EPR Compliance Assessment Report

Report ID: PP3139GB/0217317

Natural Resources Wales Technical Review Of Landfill Gas Management Systems

Hafod Landfill Gas Review
Permit No: BS8621IW

PHOTO 1 Oil Contamination From Crank Case Breather Pipe

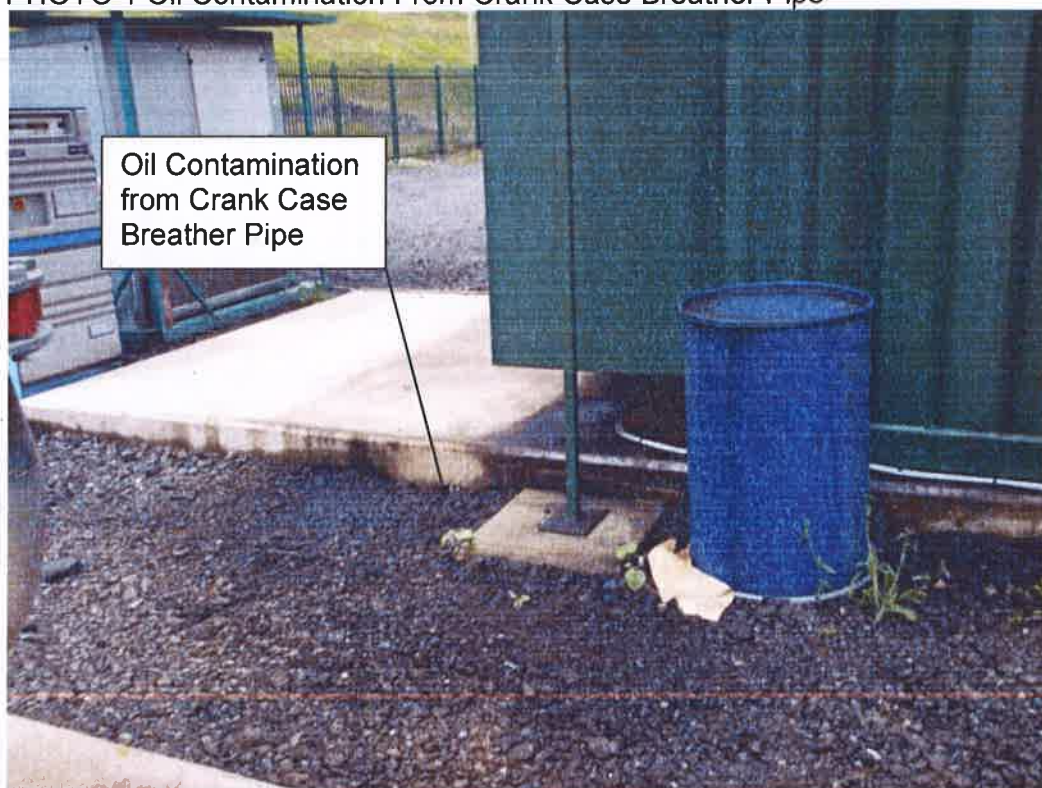
3. Oil was noted on the stone close to the gas engine housing which was coming from the crank case breather. This is to be re-routed back through the engine in the near future. It was noted that by the second morning of the audit the contaminated material had been removed and

ACTION: report on progress in re routing of crank case breather back into the engine. The following response has been received from Cory prior to the issue of the full audit findings:

ACTION 2. Please explain if this is best practice, as many of the engines at sites regulated by NRW re-route the crank case breather discharge back into the engine for combustion.

On the CAT 3516 engines the crankcase emissions are sucked from the engine via a fixed pump which then sends the emissions to the exhaust via a Vokes filter unit. Since the audit the filters have been replaced and secondary containment installed to catch any possible residue entering the outside of the genset.. In addition to the removal of any contaminated stone, the side of the genset container has also been thoroughly cleaned of any oil/dirt residue.

PHOTO 6 : Areas Of Landfill With Little Apparent Gas Infrastructure.

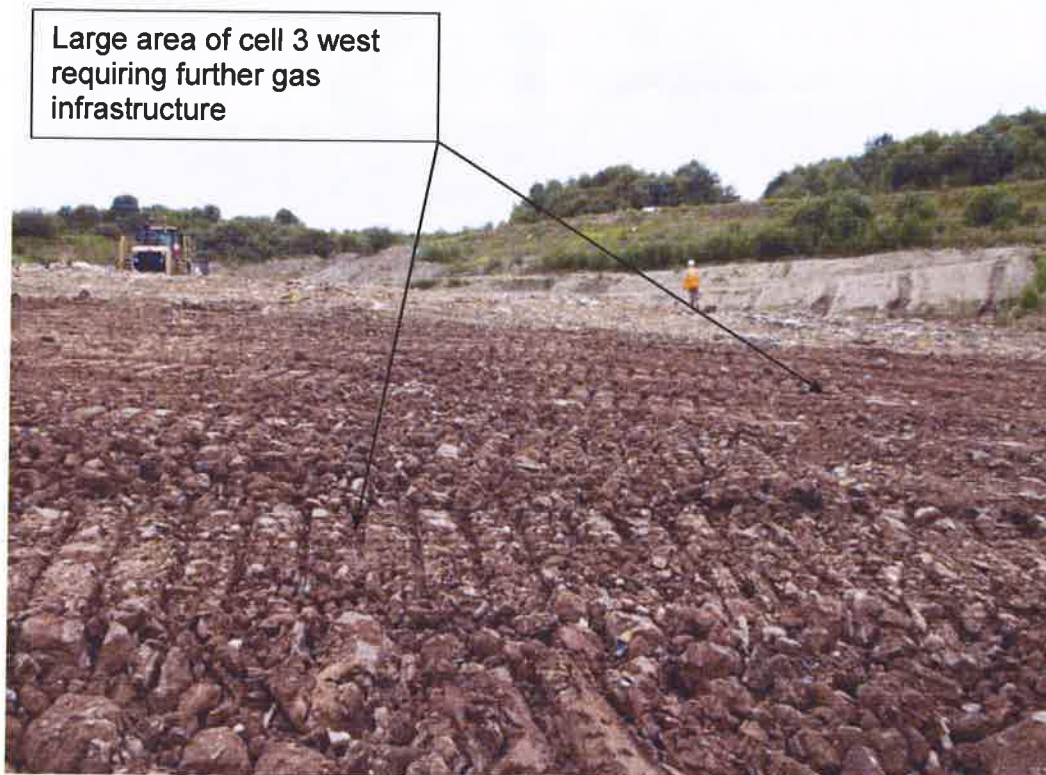
16. There appeared to be a lack of well coverage in the newly tipped and covered areas on the Western side of the slope of phase three.
ACTION: Install extraction infrastructure by the 31st October 2014.

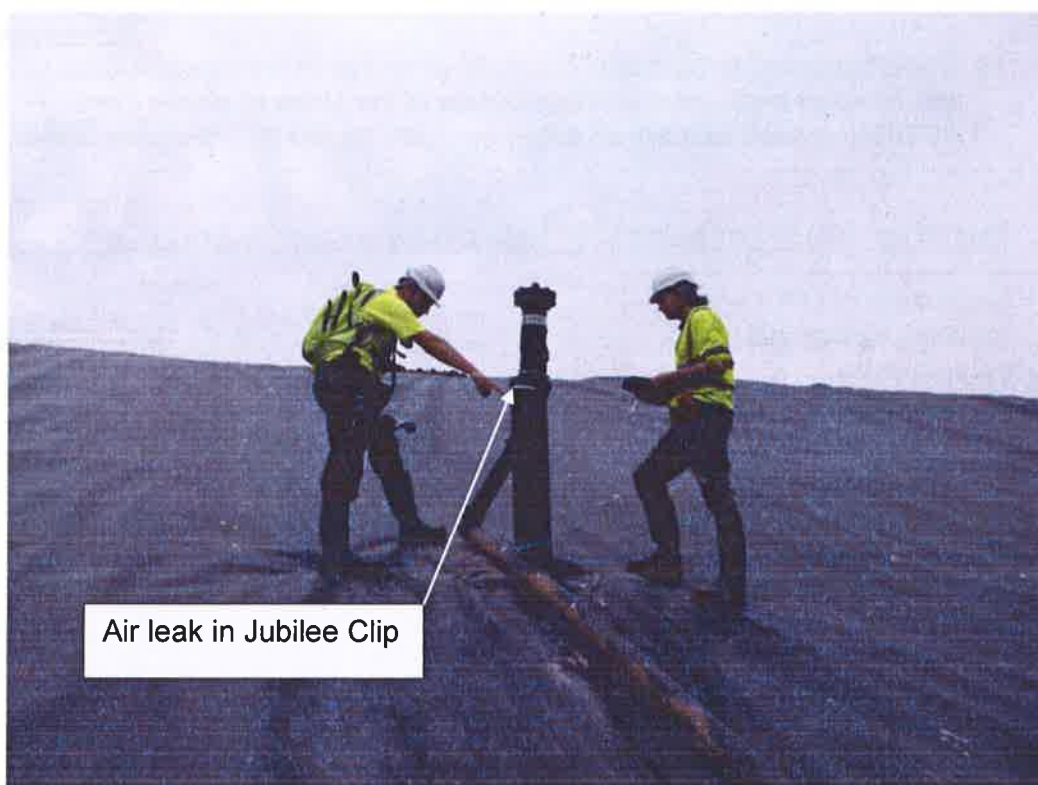
17. There were some wells with no control valve at the well head.

ACTION: Please fit control valves to well head where required within 7 days of the date of this report.

Photograph 1.1:- North Flank Cell 3,
Eastern section. Showing area of flank
in process of being regraded

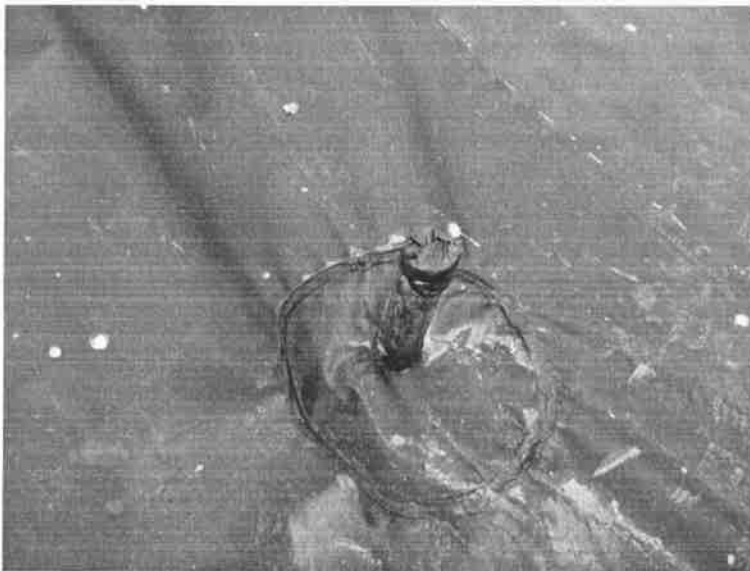
Point ref.	Methane Reading	Feature and / or Grid Reference	Description / Comment
1.	896	SJ3103345435	Cell 3 Northern Flank Eastern section (uncapped). Slope in the process of being regraded (to be completed in the next two days) in preparation for final geomembrane deployment. This layer will form the drainage layer (regulating layer under temporary cap) See Photo 1.1

Photograph 1.3:- leak in
geomembrane folds.

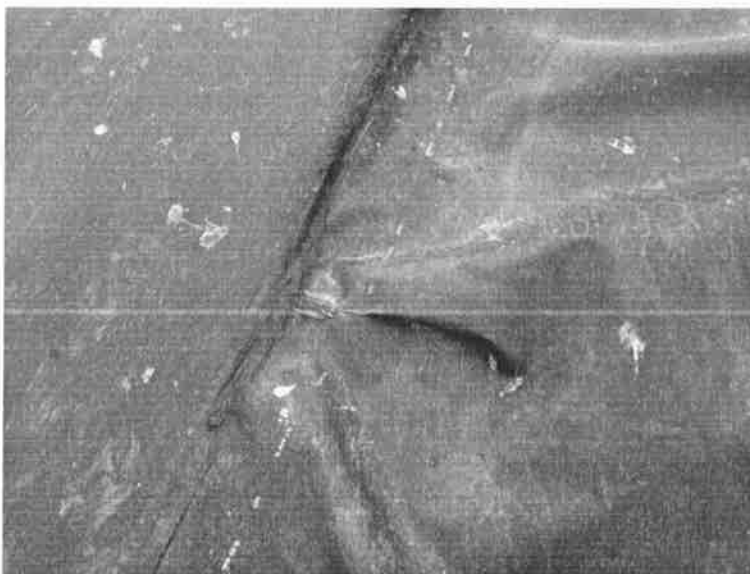
Point ref.	Methane Reading	Feature and / or Grid Reference	Description / Comment
9.	1.1%	SJ 30957 45452	Fold/crease in geomembrane. This needs to be patched when the next geomembrane deployment occurs. Staff should check rest of existing temp cap for similar folds and have them patched. Photo 1.3

Photograph 1.4:- geomembrane around Leachate well MP2.

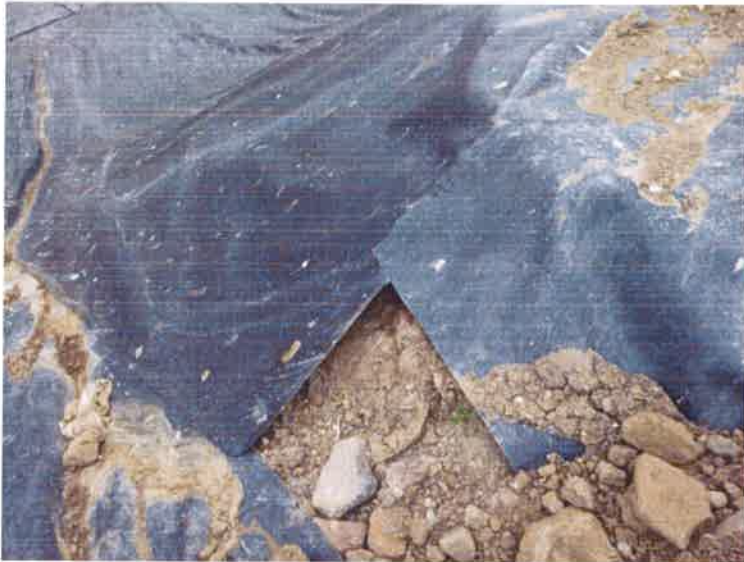
13.	10.2%	SJ 3092945430	Plastic seal around Leachate Well MP2 (to the west of well)
14.	0.2%	MP2	Boot detail around the well.
15.	219	SJ3091645436	Anchor Trench

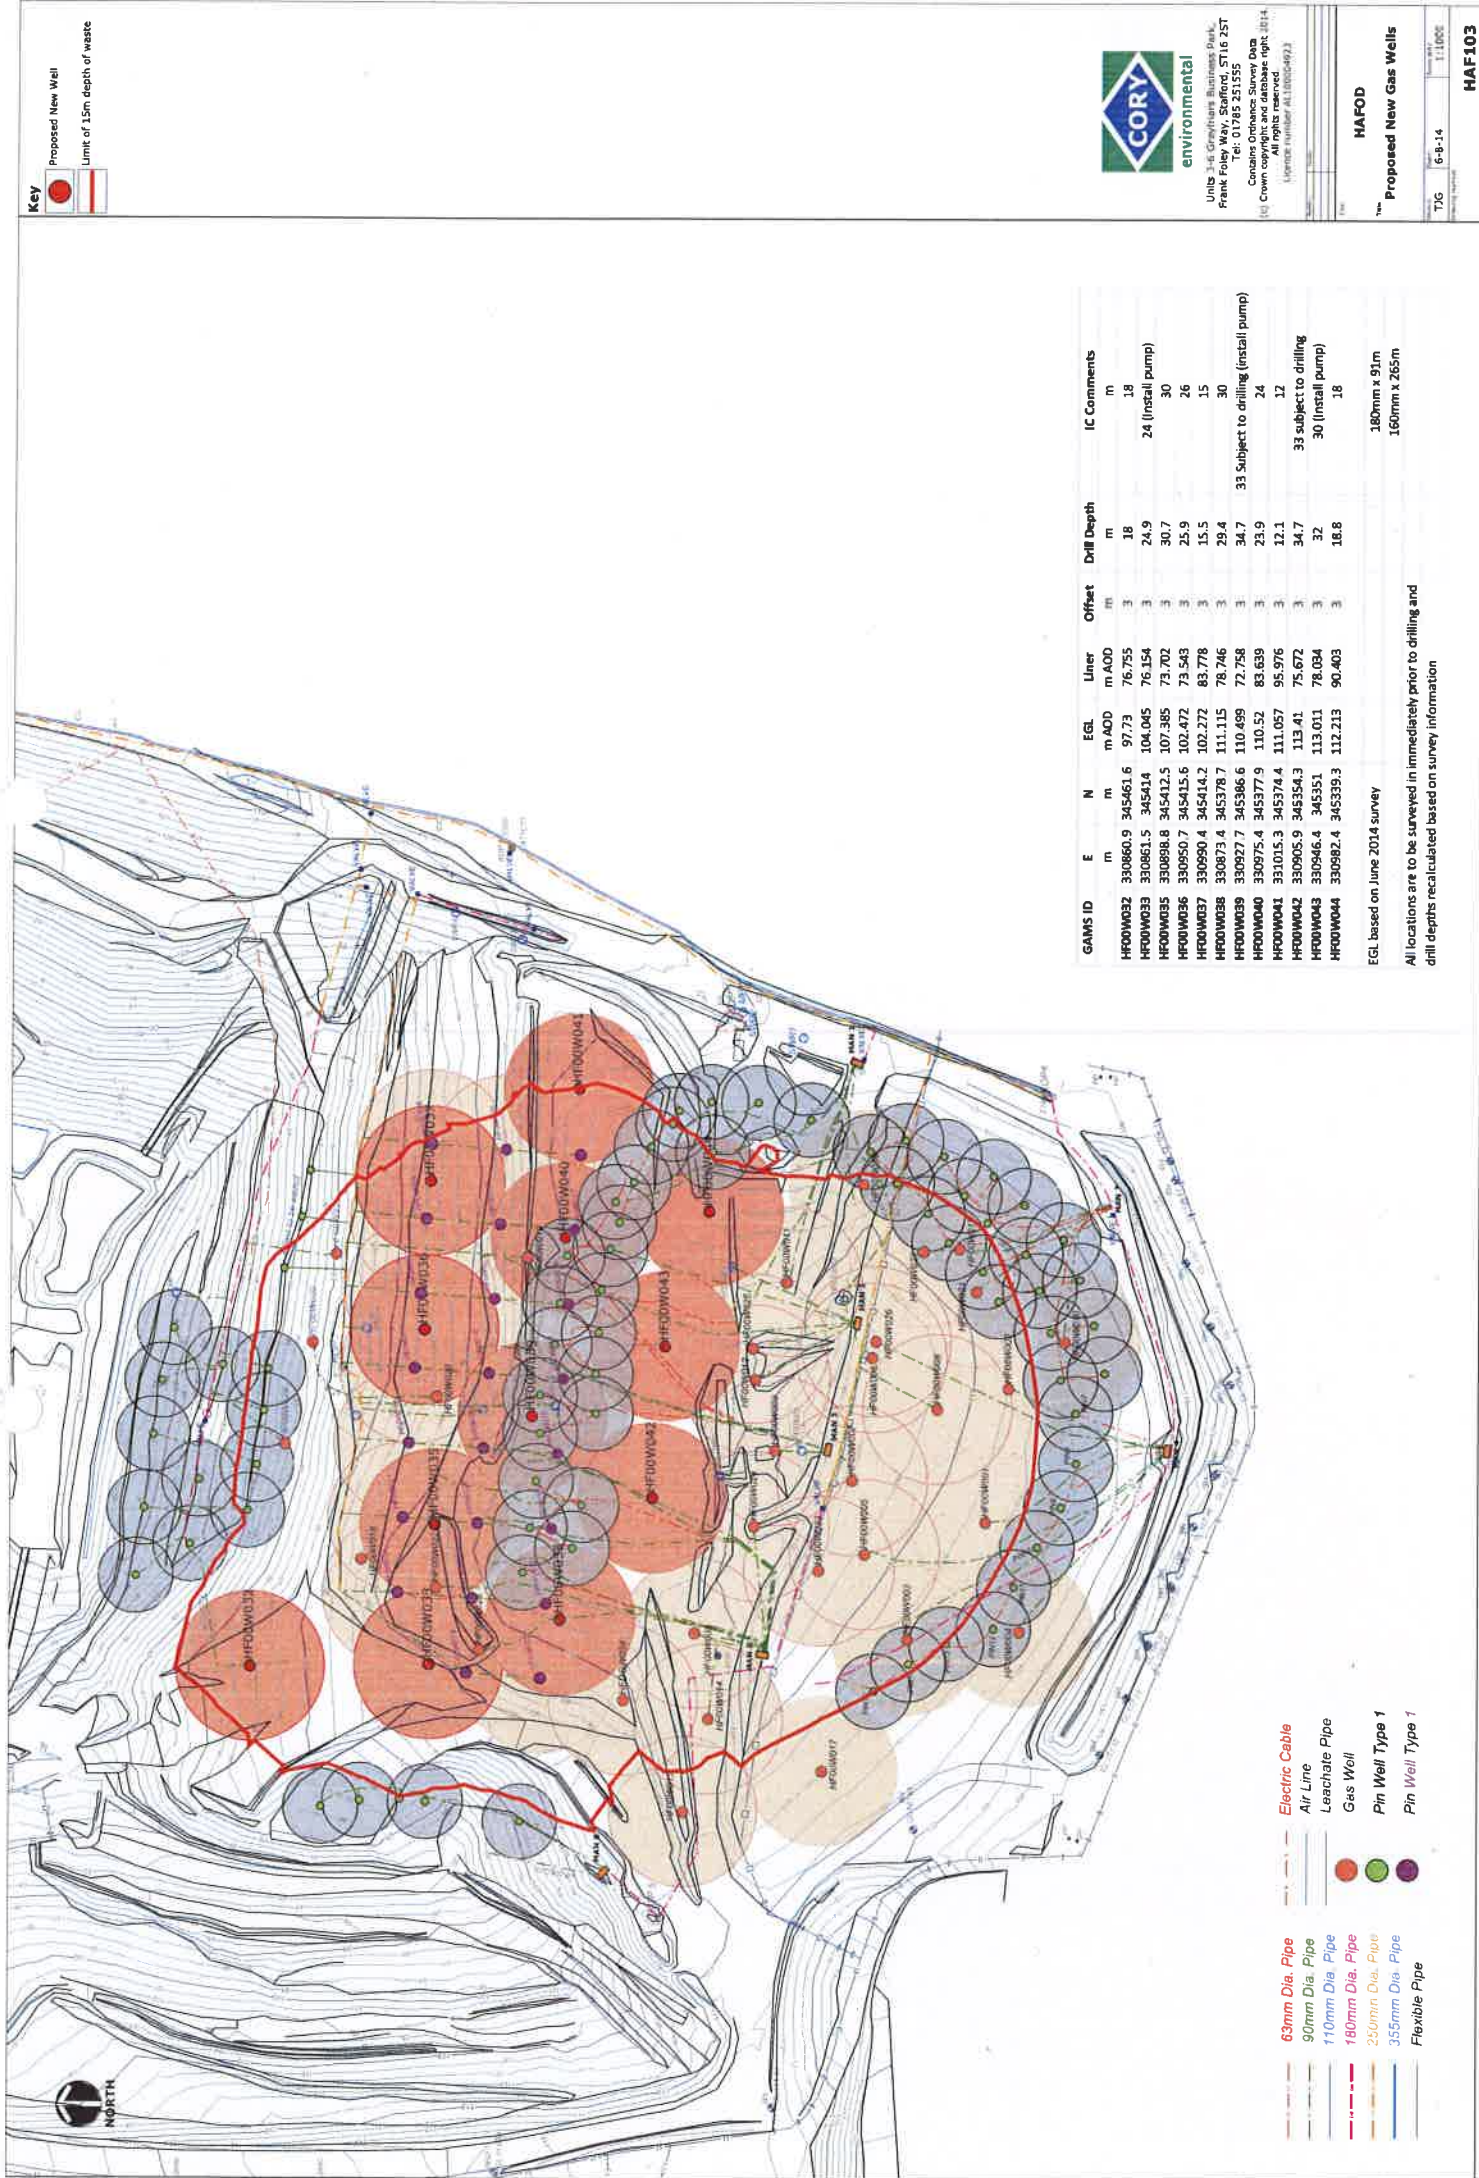
- As-built Drawing supplied (Dated Jun 2014) but was inaccurate and we have asked for updated drawing to be provided showing all infrastructure.
